DETERMINATION OF NON-SIGNIFICANCE

City of Bellevue Utilities Yarrow Creek Stream Stabilization and Habitat Improvements

**City of Bellevue
Development Services Department
Land Use Staff Report**

File Number: 10-130253-LO

YARROW CREEK STREAM RESTORATION
STREAM CHANNEL DETAILS

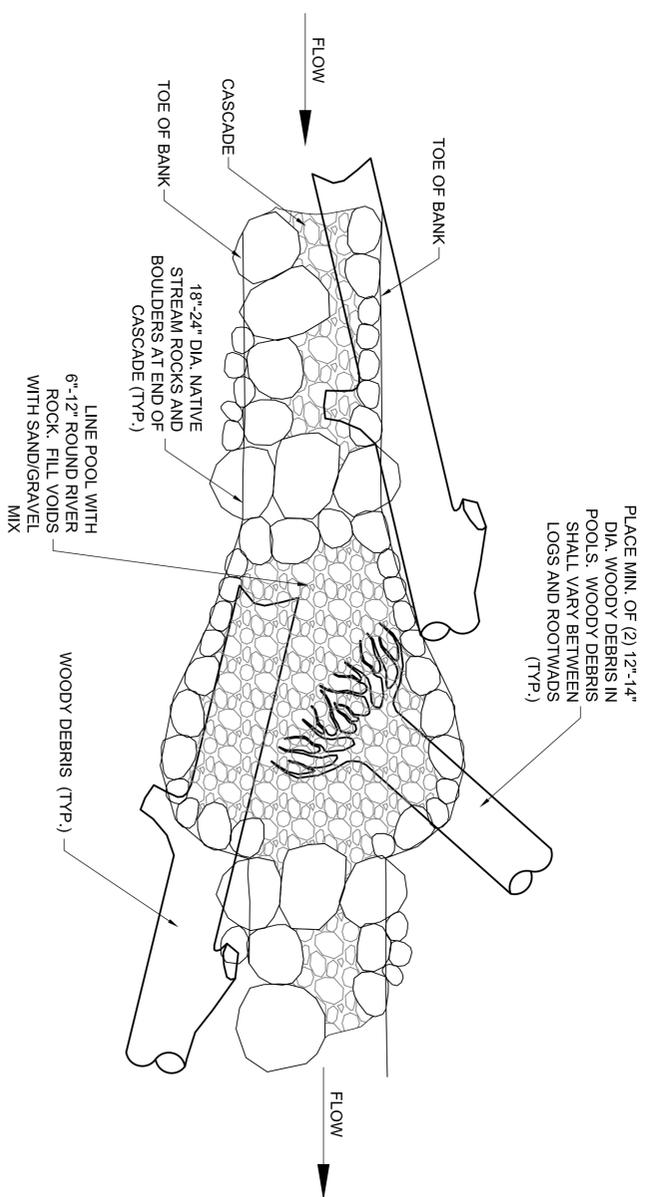
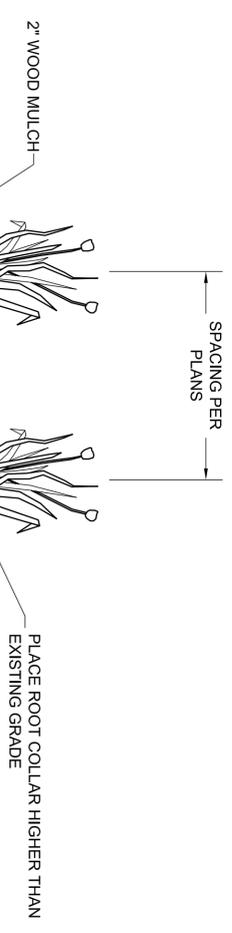
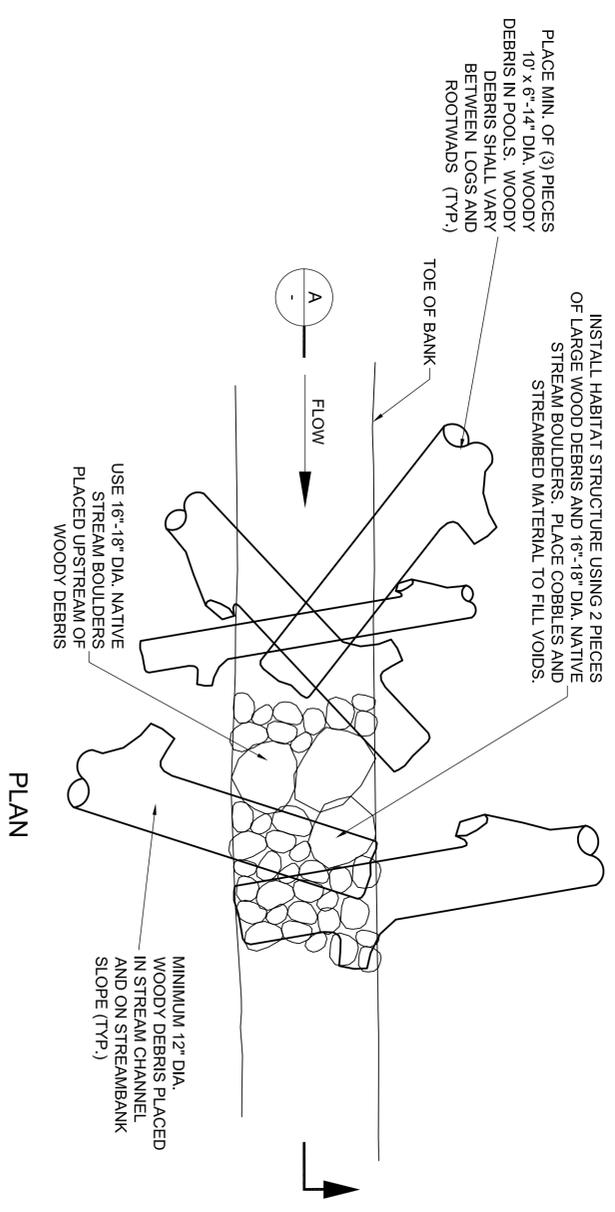
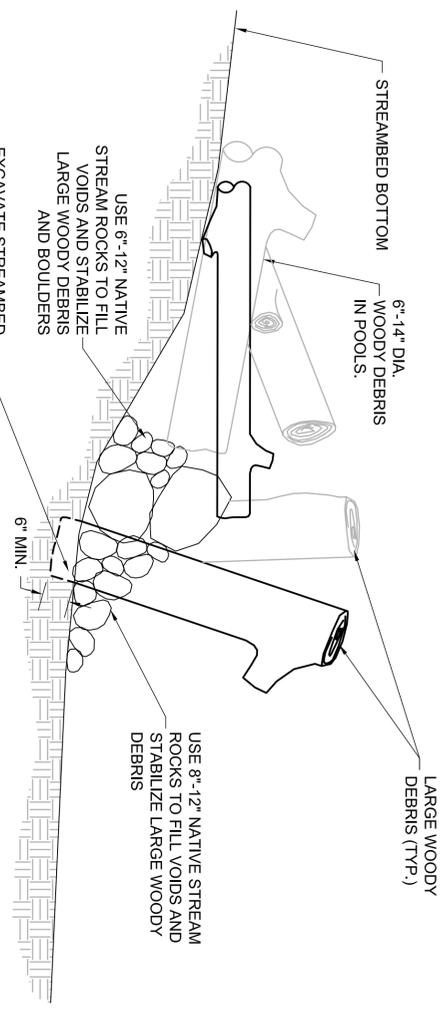
From the project drawings, Sheet 3 of 8, the new project will daylight 85+feet of channel that was filled with the emergency project. As part of this work, the new project will create pools and cascades as shown in Sheets 7 and 8. The pool feature shown in Detail A/3 should be continued down into the portion of the project below the new stilling well as this is the area where the stream will receive all of the potential flows, is lower gradient and closest to the West Tributary of Yarrow Creek where we expect salmonids to be able to access once the downstream culverts are fixed. Pools in the upper reach above the stilling well may have limited access in the wet season for salmonids in the future because the majority of the flows (at least 2 year flows and greater) will be routed to the high flow by-pass pipe. This change in flow regime, combined with the steeper channel gradient may limit access for salmonids. As a result, there would be more value in creating pools below the stilling well that would likely be more accessible for salmonids. To achieve this objective, Bruce and I discussed adding additional wood to this downstream reach and vary the sizes to provide more wood diversity and increased wood loading than what is shown on Sheet 3. Bruce agreed that the project could be modified to add more wood provided it can be brought in by hand as the project is not proposing to use heaving equipment in this reach due to a lack of road access.

The comment letter is included as **Attachment 3**. Staff response to the comments is included as **Attachment 4**. As a result of comment received, the project design was modified to add additional wood of varying sizes to the downstream reach to create additional pools and improve in-stream habitat conditions in an effort to plan for fish passage improvements proposed as part of the State Highway 520. Revised plans were submitted on March 31, 2011 reflecting the requested changes.
